UNITED STATES PATENT AND TRADEMARK OFFICE

APPLICATION NO.	FILING DATE	FIRST NAMED INVENTOR	ATTORNEY DOCKET NO.	CONFIRMATION NO.
10/660,402	09/10/2003	Eric G. Lott	LOTA101	5840

Office Action Summary	Application No.	Applicant(s)	
	10/660,402	LOTT, ERIC G.	
	Examiner	Art Unit	
	Yvonne M. Horton	3635

DETAILED ACTION

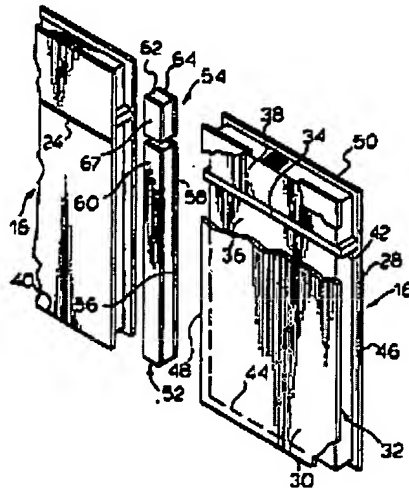
Claim 2 stands rejected under 35 U.S.C. 103(a) as being unpatentable over Taraba et al in view of Petersen, US Patent # 4,224,774. Taraba discloses the claimed invention as stated above in claim 1, including the first and second skin pieces define a

width and the foam core piece defines a depth (see figure below). Taraba does not disclose the depth being greater than the width.

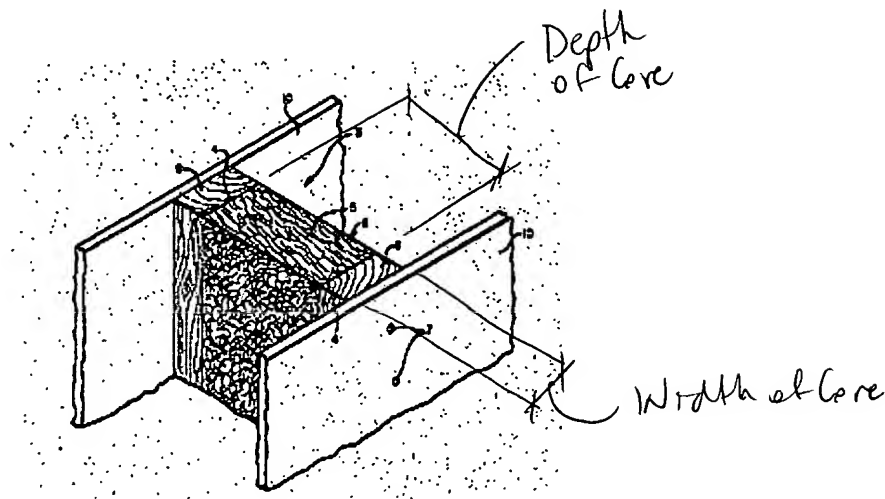
Petersen teaches that it is known in the art to provide an engineered lumber stud (3) with a first and second skin (8 and 9) of lumber (column 2, lines 41-42) with a foam core piece positioned therebetween (5, 6) and that the depth of the foam is greater than the width of the skins (see figure on next page). It would have been obvious to one having ordinary skill in the art at the time the invention was made to provide the dimensions of core and skins as taught by Petersen with the stud of Taraba in order to increase the depth of the walls of the wooden frame buildings (column 1, lines 54-56).
